*Staff Presentation to the
Portland Design Commission*

Design Advice Request
EA 15-203240 DA
710 SW Columbia

November 5, 2015

3. West Wall Materials

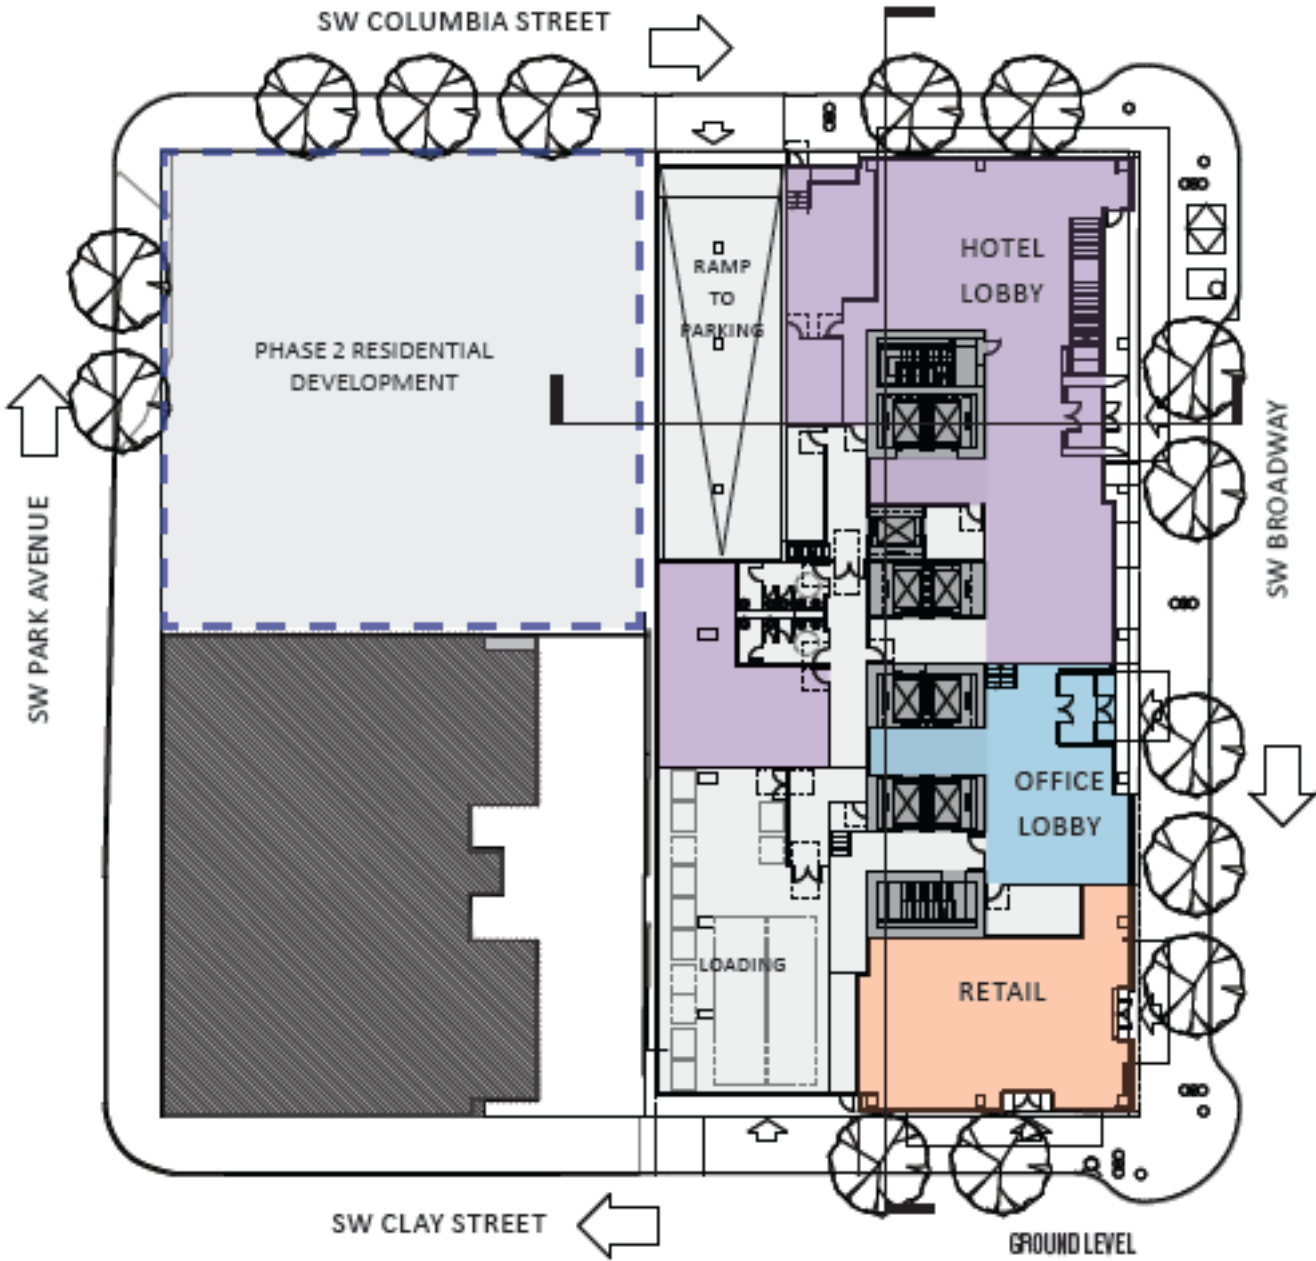
Aluminum and glazed curtain wall vs. terra cotta or pre-cast concrete

Buildings on Park Blocks are primarily brick

South & North Elevations

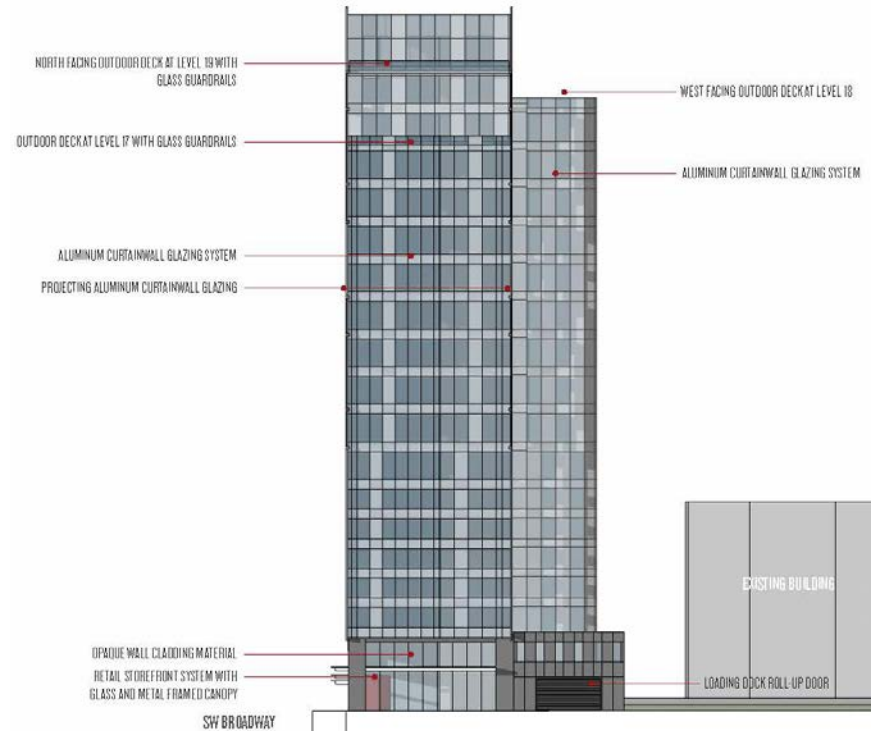
Potential Ground Floor Windows Modifications
